OVERTURN 320 Alamitos

FOLLOW THE RULES

PROTECT OUR
NEIGHBORHOOD

320 Alamos

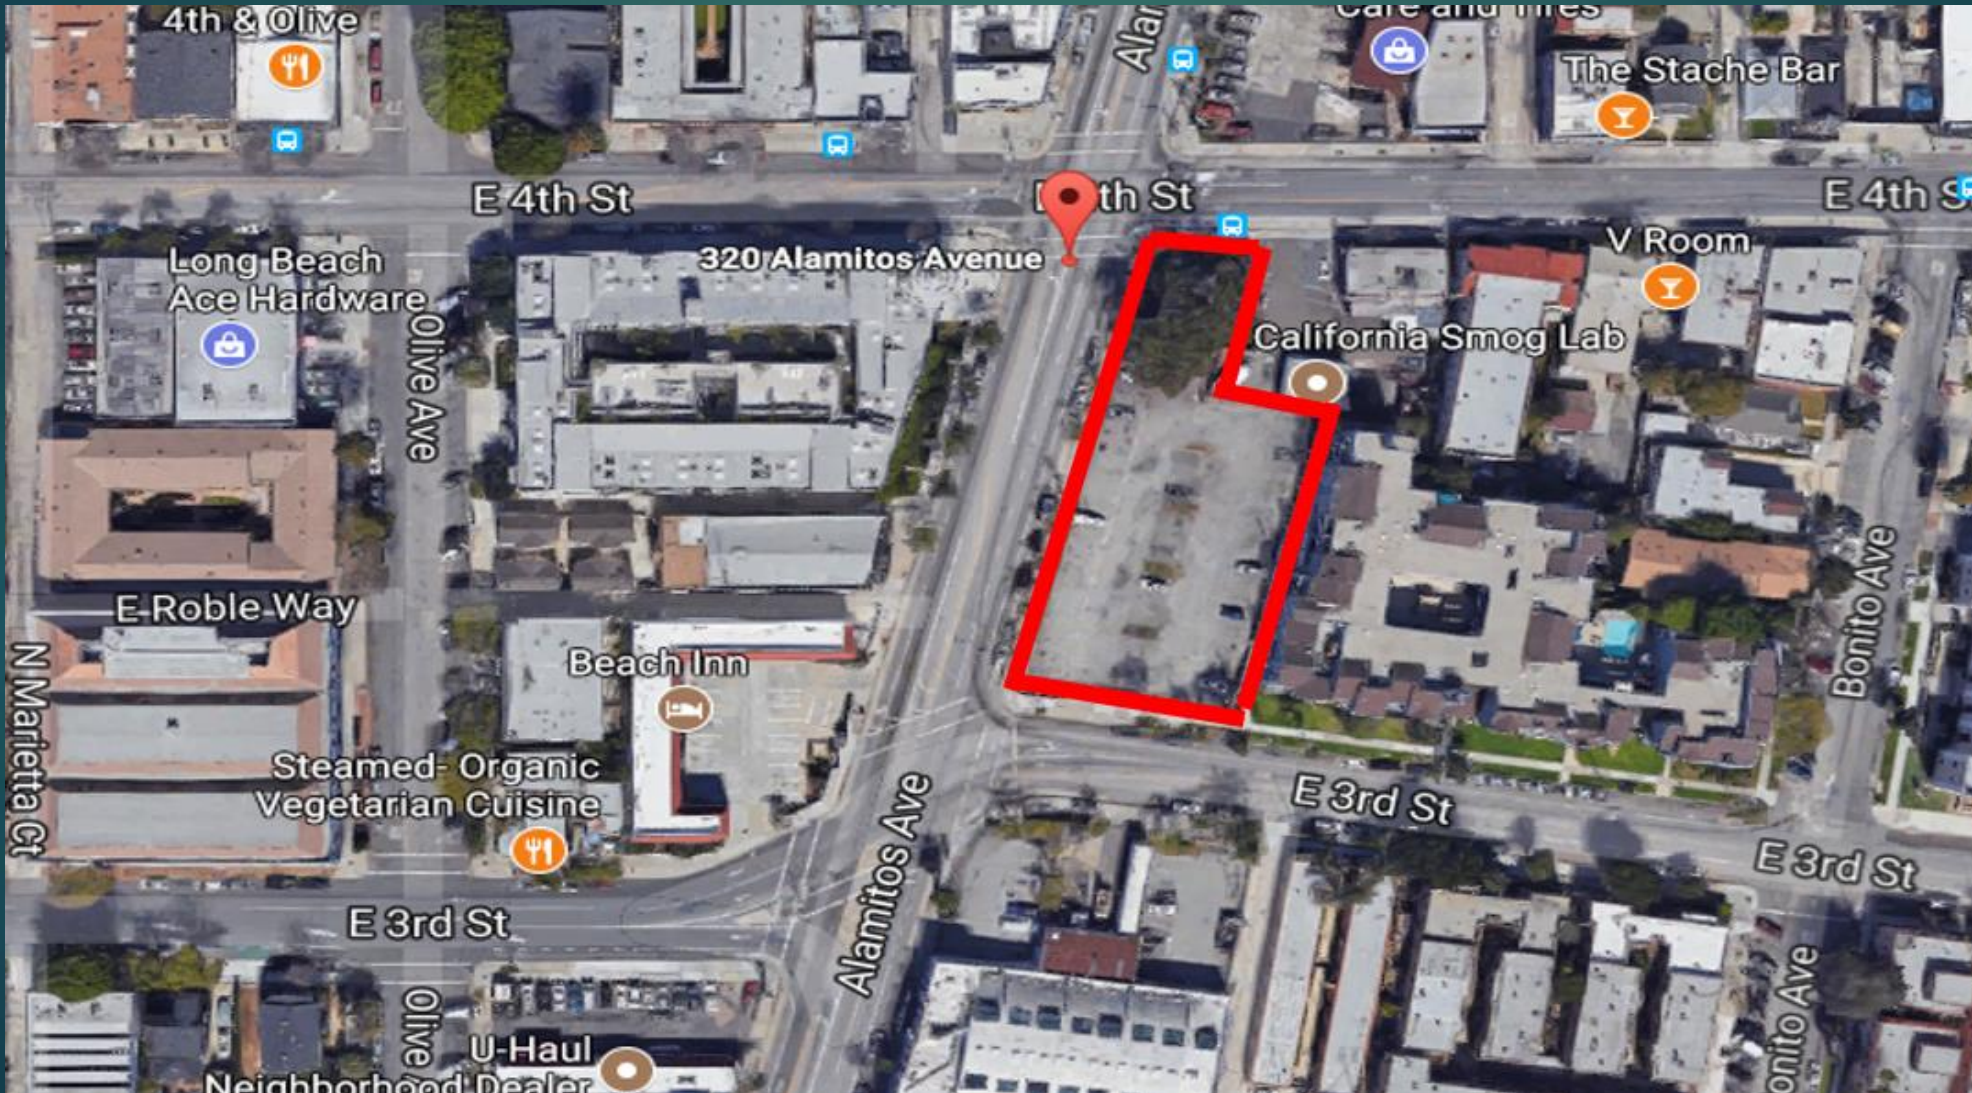
Standard #2 *New buildings shall respect the **SCALE** of adjacent structures and respond to their elements in an appropriate manner.*

- ▶ **7 stories is out of scale** & in appropriate for this neighborhood
- ▶ **Most buildings** are only **1 and 2 stories** tall in our neighborhood – **nothing close to 7 stories**

FAILS to Meet Guidelines

The **massing and design** of mid-rise buildings should be sensitive to adjacent scales and **carefully address the transition to lower height structures** that may exist or be anticipated on the same block

- ▶ **Significantly taller - Insensitive** to the scale of adjacent buildings
- ▶ **Jarring & Abrupt transition** to lower height buildings
